Access Compliance Report

Public Rights-of-Way

Intersection ID: 47614	Main Street: WYALONG_DR	Cross Street: MACQUARIE_LN	Location: NE
ADA ID: 90A3F4B36ED5	Ramp Type: BlendTrans1	Initial Pass/Fail: Fail	Overall Compliance: No
		Severity Score: 12.5

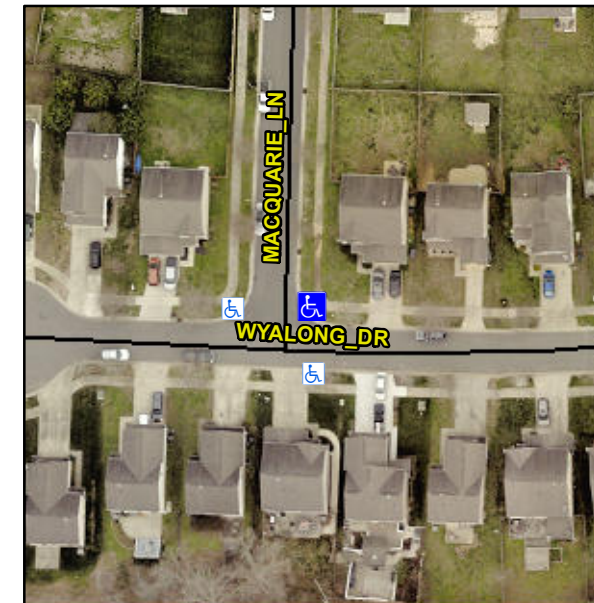
Not Found, R304.5.3

Compliance	Description	Data	Compliance	Description	Data
N/A	Ramp Length (in)	72.0	Yes	BlendTrans Slope (%)	3.5
Yes	Ramp Width (in)	48.0	No	BlendTrans XSlope (%)	5.1
N/A	Flare Type LT	N/A	N/A	Flare Type RT	N/A
N/A	Flare Slope LT (%)	N/A	N/A	Flare Slope RT (%)	N/A
N/A	Flare Traversable LT?	N/A	N/A	Flare Traversable RT?	N/A
N/A	Landing Length (in)	N/A	N/A	DWS Provided?	N/A
N/A	Landing Width (in)	N/A	N/A	DWS Contrast?	N/A
N/A	Landing Slope (%)	N/A	N/A	DWS Length (in)	N/A
N/A	Landing X Slope (%)	N/A	N/A	DWS Full Width?	N/A
N/A	Landing Curb? (Y/N)	N/A	N/A	DWS Offset (in)	N/A
N/A	Shared Landing?	N/A			
N/A	Gutter Ponding?	N/A	N/A	Gutter Slope (%)	N/A
N/A	Gutter Lip Ht (in)	N/A	N/A	Gutter X Slope (%)	N/A
N/A	Painted X Walk1?	No	N/A	Painted X Walk2?	No
	X Walk 1 Direction	To W		X Walk 2 Direction	To S
	X Walk 1 Width (in)	N/A		X Walk 2 Width (in)	N/A
	X Walk 1 Slope (%)	1.9		X Walk 2 Slope (%)	3.6
	X Walk 1 X Slope (%)	2.8		X Walk 2 X Slope (%)	1.6

N/A	Ramp inside XWalk1?	N/A	N/A	Ramp inside XWalk2?	N/A
	Road Slope (%)	2.3		Clear Space?	N/A
	Road X Slope (%)	0.0	N/A	Clear Space to XWalk (in)	N/A
N/A	Any Obstructions?	N/A	N/A	Storm Grate/Utility Hazard?	N/A
	Obstruction Type			Storm Grate/Utility Type	
		N/A			N/A
			Yes	Surface Condition? (G/P)	Good
			No	Curb Slope (%)	12.5

Remove & Replace Curb Ramp With Two New Directional Ramps or Equivalent.
